WAYII AREA TRAIL DESIGN INDEX SHEET

--	----	----
--	----	----
--	----	----
--	----	----
1	REVISED REST AREAS	21/03/10
0	ISSUED FOR TENDER	21/02/18

TOFINO
**PACIFIC RIM
NATIONAL PARK RESERVE**
ʔapsčik tašii
(Ups-cheek ta-shee)
**“Going in the right
direction on the trail”**

WAYII AREA TRAIL DESIGN

TYPICAL TRAIL PAVING SECTION
1:50

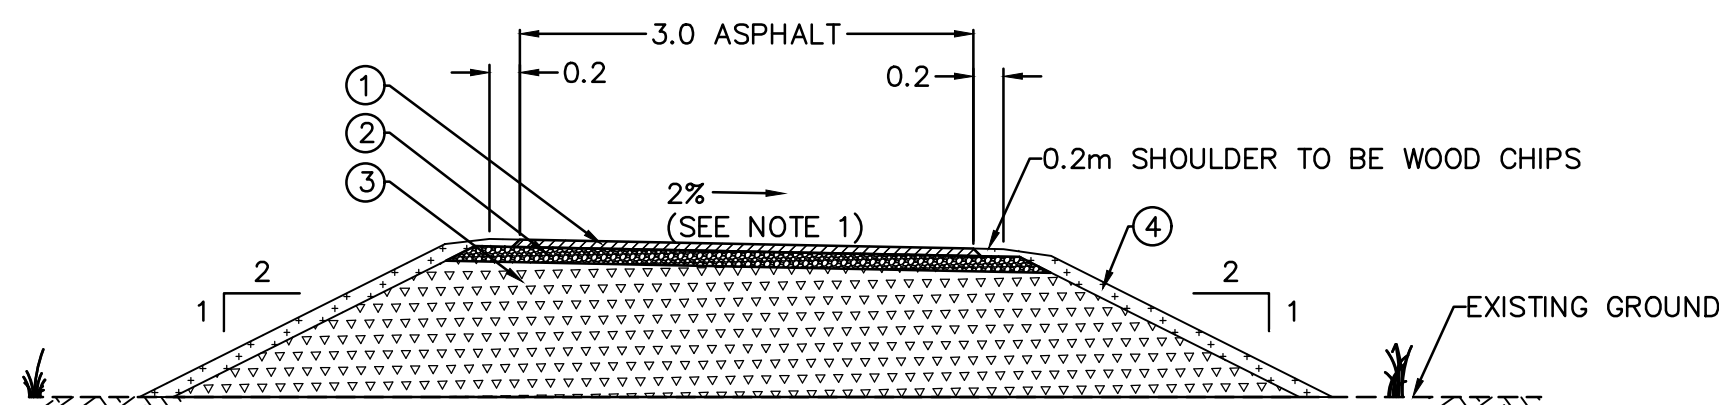
- STRUCTURE:
- 50mm ASPHALT MMCD FINE MIX
 - 100mm - 19mm GRANULAR BASE
 - EXISTING SUBBASE IS TO BE COMPACTED IN THE PRESENCE OF THE GEOTECHNICAL ENGINEER. AFTER COMPACTION, THE EXISTING SUBBASE IS TO BE TOPPED UP WITH 75mm CRUSHED GRANULAR SUBBASE TO FILL-IN LOCAL LOWS AND GRADE/LEVEL IN THE VICINITY OF NEW AND EXISTING CULVERTS. THICKNESS TO BE VARIABLE AS DIRECTED BY DIR.
 - SALVAGED ORGANICS MIN 150mm THICK AND WOOD DEBRIS PER OEM. ONLY WOOD DEBRIS/ORGANICS RESTRICTION IS NOT TO IMPEDE DRAINAGE.
- REVISED SUBBASE

TYPICAL TRAIL FILL SECTION
ORGANIC SHOULDER
1:50

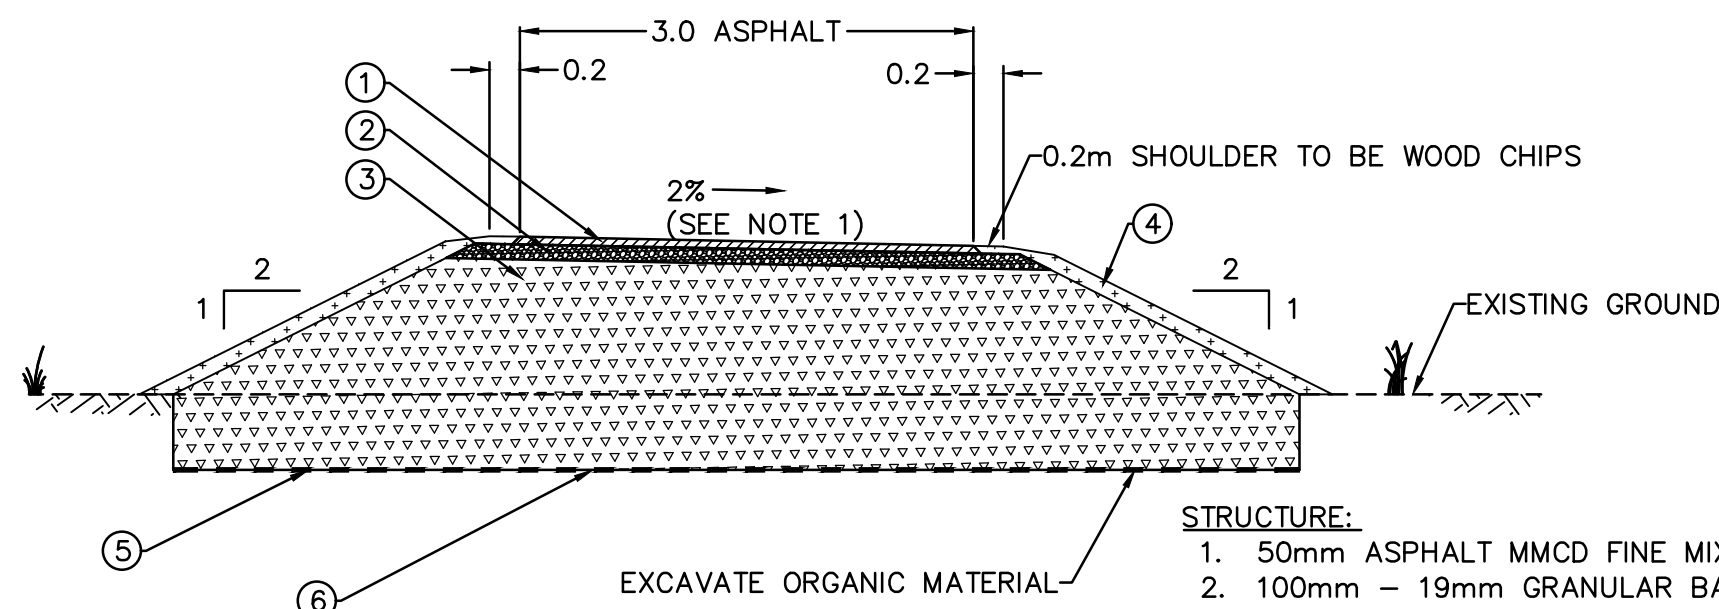
- STRUCTURE:
- 50mm ASPHALT MMCD FINE MIX
 - 100mm - 19mm GRANULAR BASE
 - MIN 450mm - 75mm PIT RUN
 - SALVAGED ORGANICS MIN 150mm THICK AND WOOD DEBRIS PER OEM. ONLY WOOD DEBRIS/ORGANICS RESTRICTION IS NOT TO IMPEDE DRAINAGE. SEE ENVIRONMENTAL DRAWINGS EN-01 TO EN-04 FOR DETAILS.
 - COMPOSITE GEOGRID TE-BXC30 OR APPROVED EQUIVALENT (NO COMBI-GRID REQUIRED FROM STA 0+450 TO STA 0+528)
 - GEOTECHNICALLY APPROVED UNDISTURBED SUBGRADE
 - SLOPE/EMBANKMENT HEIGHT LESS THAN 2m
- REVISED COMBIGRID

TYPICAL TRAIL FILL SECTION
SLOPE/EMBANKMENT < 2m HIGH
1:50

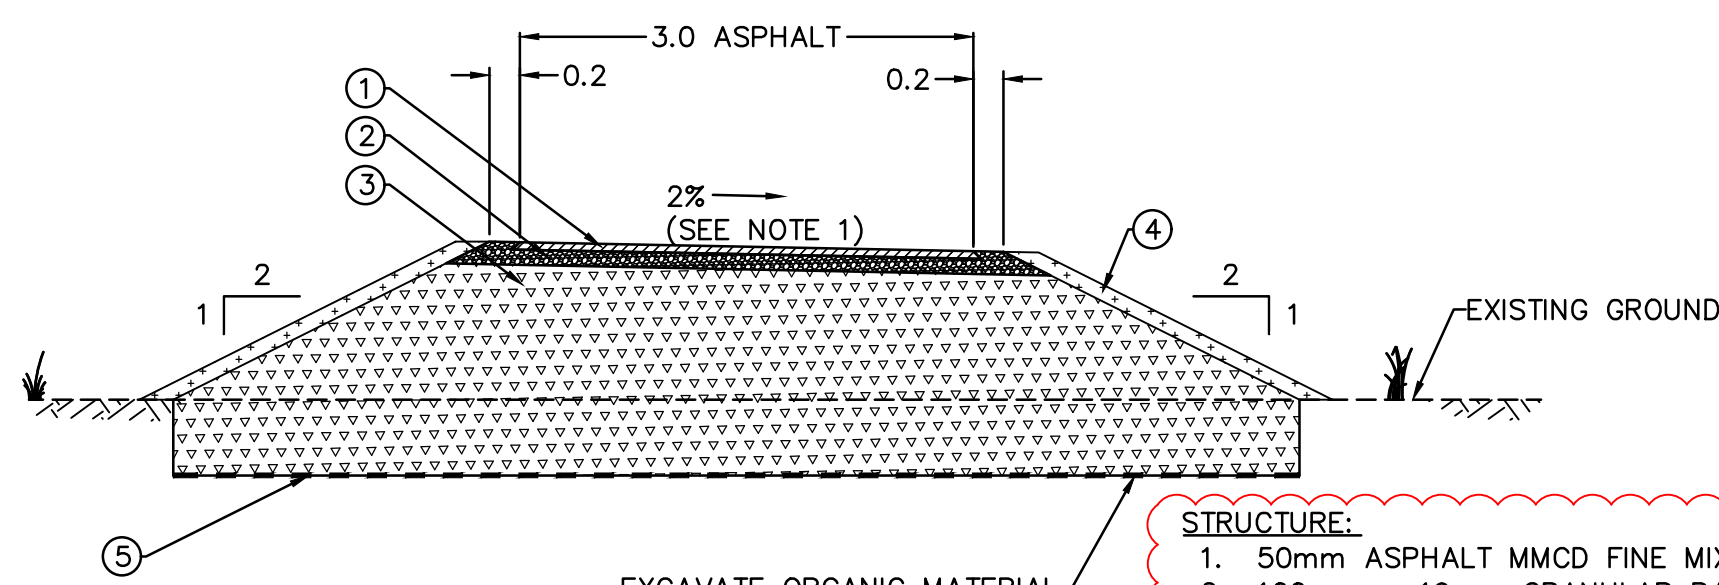
- STRUCTURE:
- 50mm ASPHALT MMCD FINE MIX
 - 100mm - 19mm GRANULAR BASE
 - MIN 450mm - 75mm PIT RUN
 - SALVAGED ORGANICS MIN 150mm THICK AND WOOD DEBRIS PER OEM. ONLY WOOD DEBRIS/ORGANICS RESTRICTION IS NOT TO IMPEDE DRAINAGE. SEE ENVIRONMENTAL DRAWINGS EN-01 TO EN-04 FOR DETAILS.
 - GEOTECHNICALLY APPROVED UNDISTURBED SUBGRADE
 - SLOPE/EMBANKMENT HEIGHT LESS THAN 2m
- REMOVED COMBIGRID

Drawing title/Titre du dessin	WAYII AREA TRAIL DESIGN SLOPE SECTION I STA 0+395
-------------------------------	---

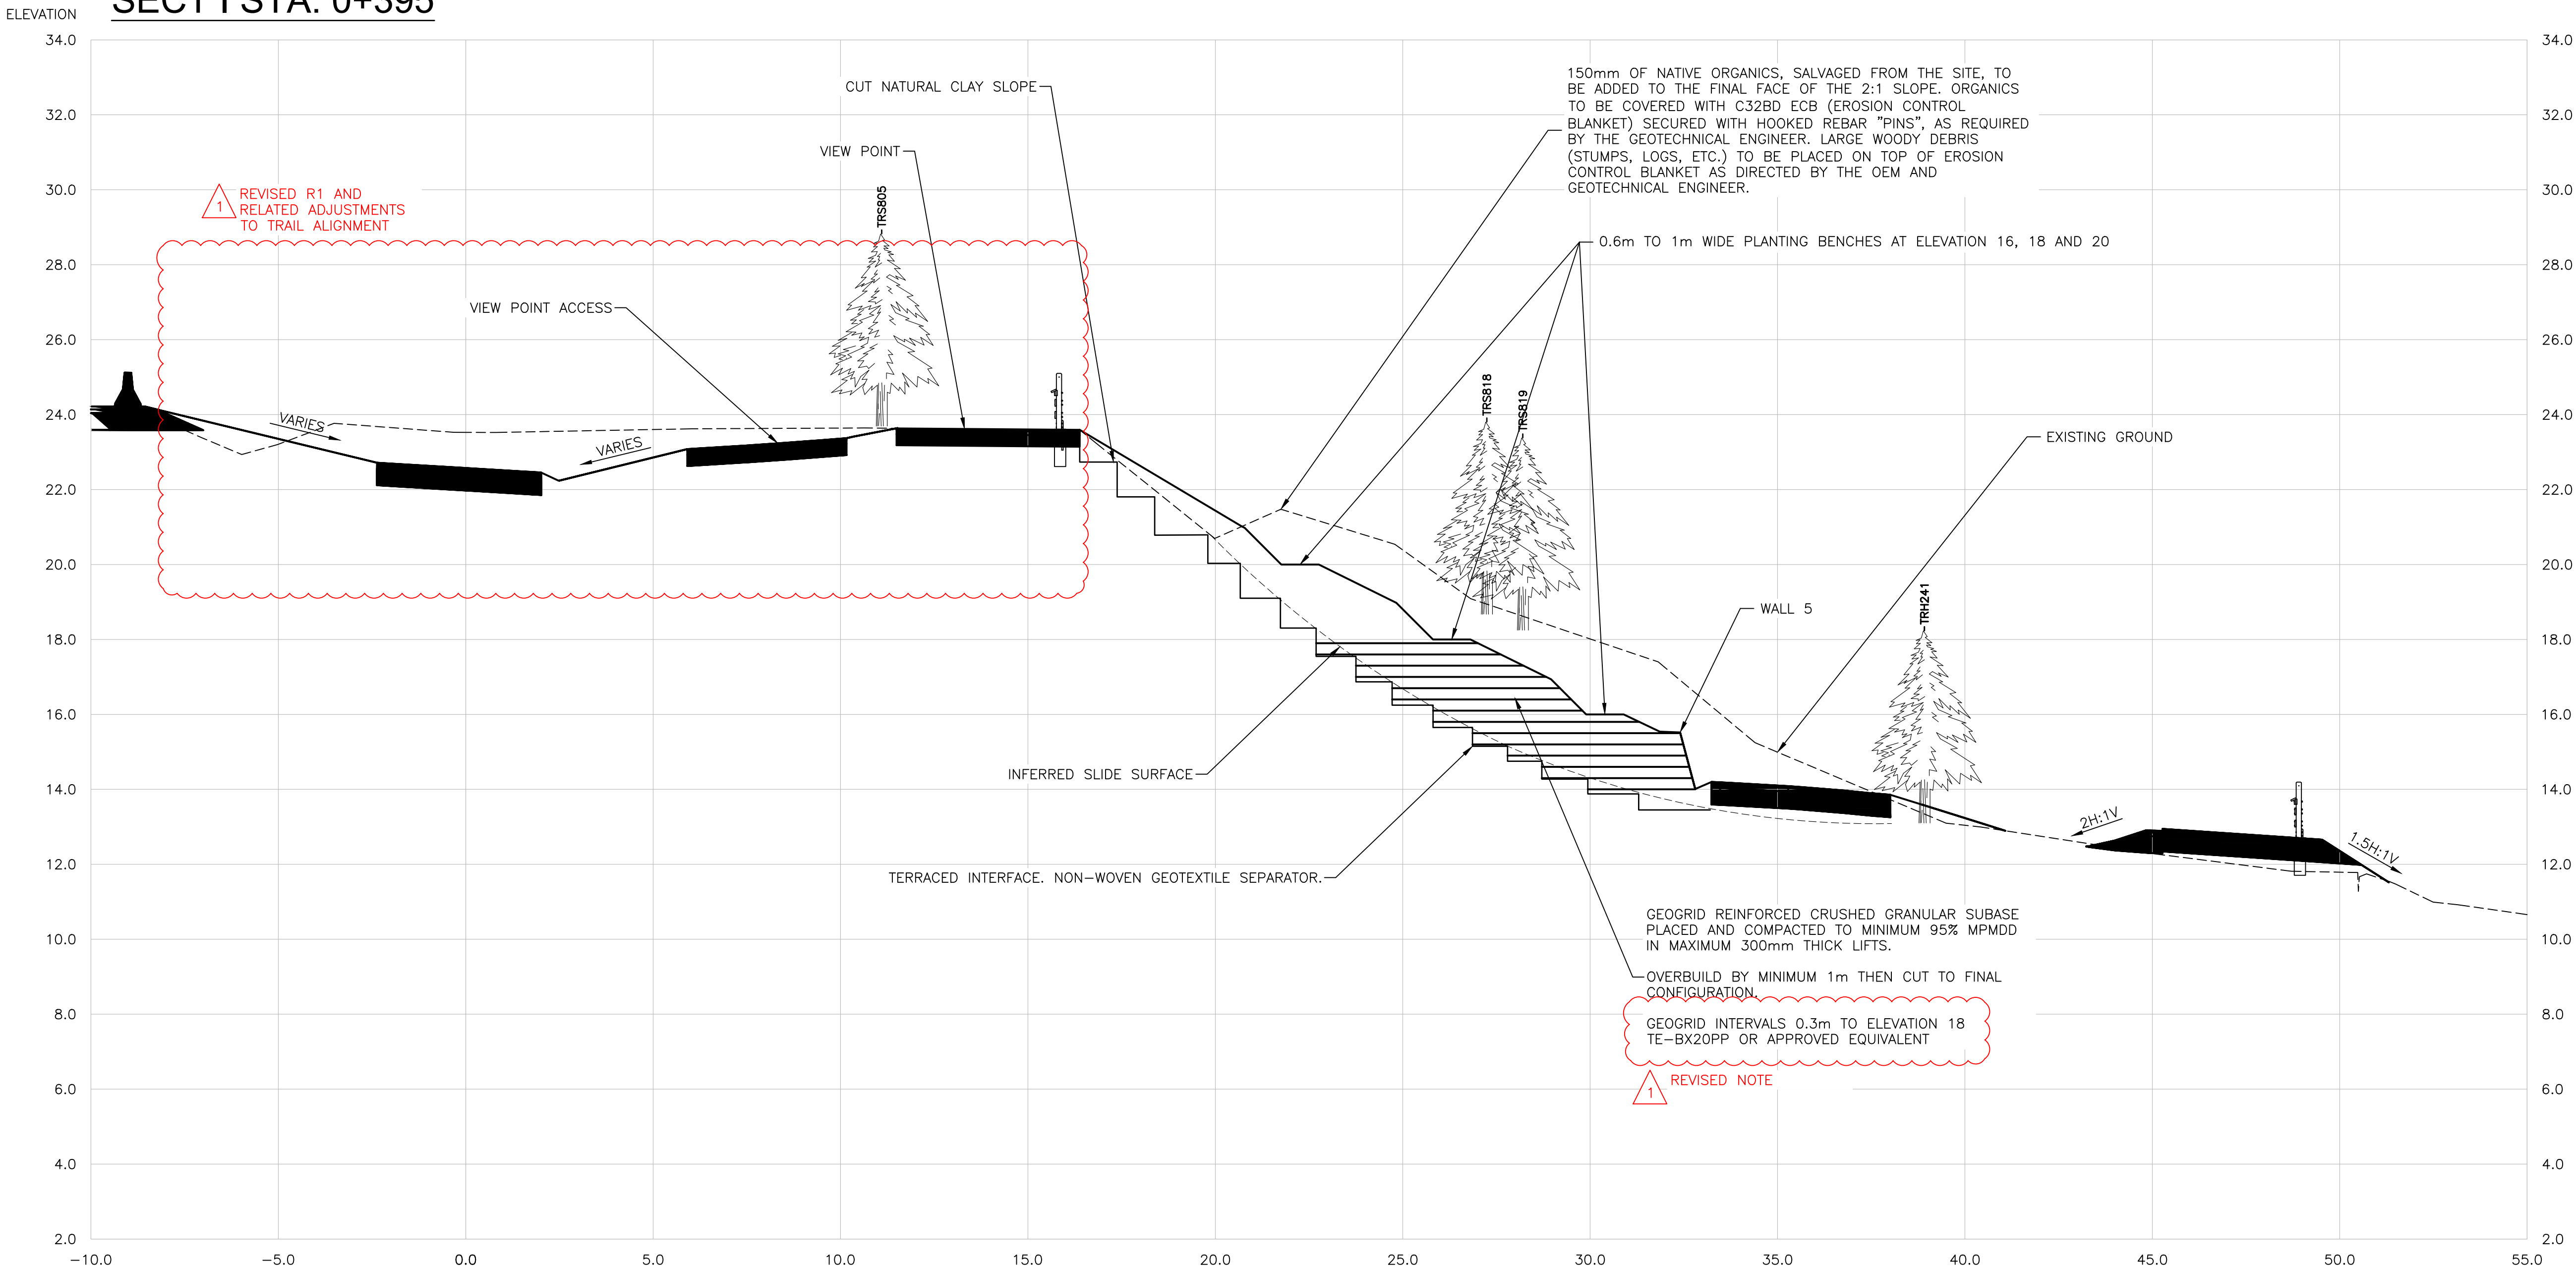
1	REVISED R1 AND RELATED ADJUSTMENTS TO TRAIL ALIGNMENT	21/03/10
0	ISSUED FOR TENDER	21/02/18
